E398-No or Distorted Earpiece Audio

Our Reference: SI70_12_2004

Product/System: **E398**

FIELD SERVICE INFORMATION

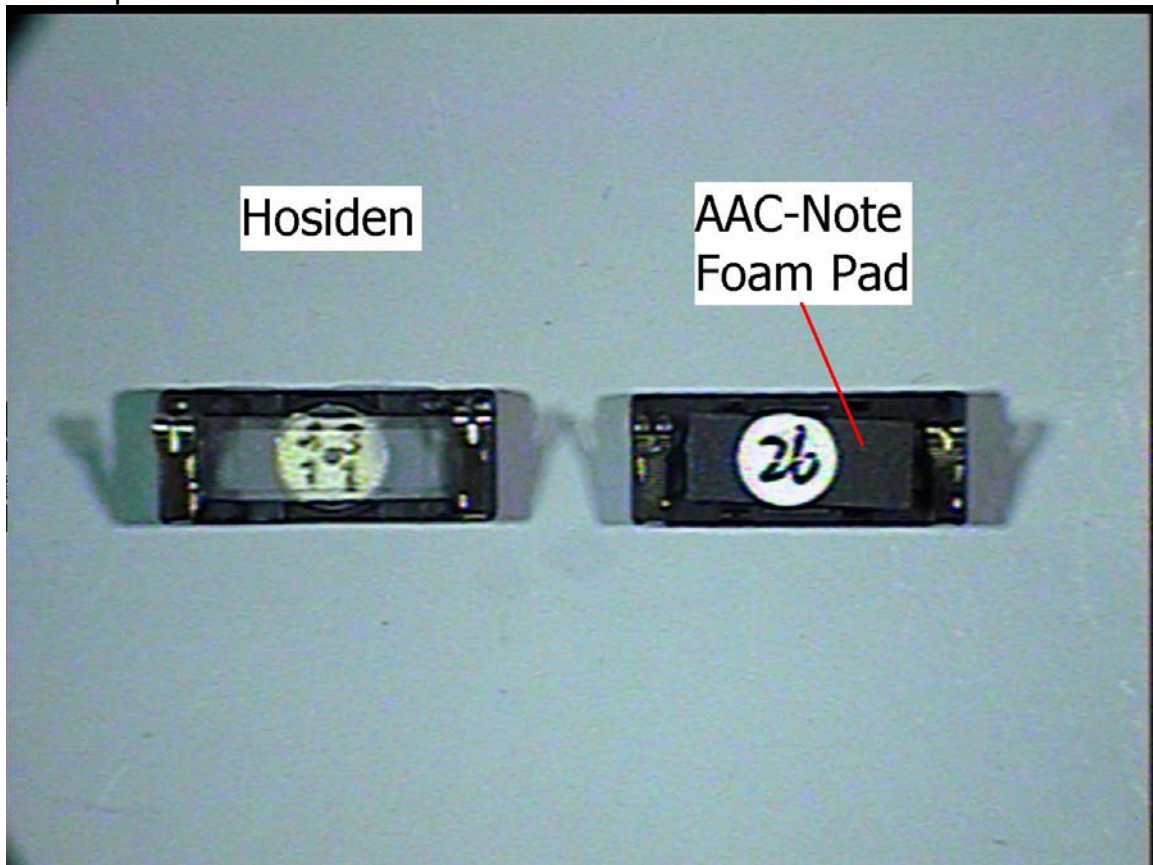
- 2) Observe the contact side of the Earpiece to determine if the manufacturer is Hosiden. The photo below shows Hosiden vs AAC Earpiece. Notice that the AAC Earpiece has a foam pad attached to the contact side (rear) of the component.

- 3) If the manufacturer is confirmed to be Hosiden, replace the Earpiece with AAC.
Note: Do not remove the foam pad from the AAC Earpiece. The foam pad remains attached to the earpiece.
- 4) Reassemble the unit and verify that earpiece audio is now functional.
